ERRATA for
FE Mechanical Practice Exam
ISBN: 978-1-932613-85-8
Copyright 2017
Errata posted 11/8/2018

Solution 26, p. 93:

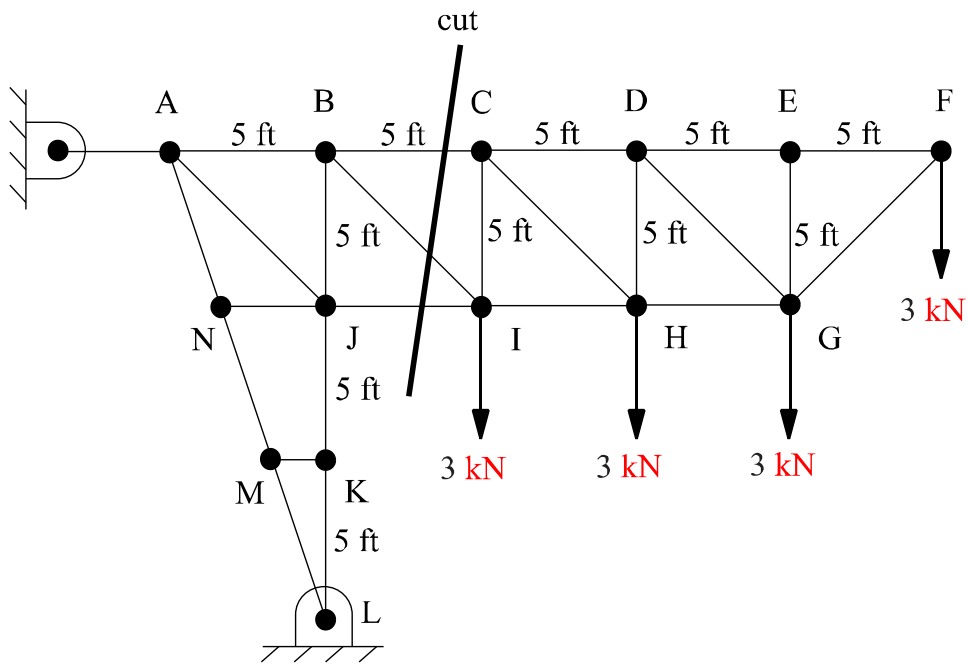
The figure should be shown as follows:
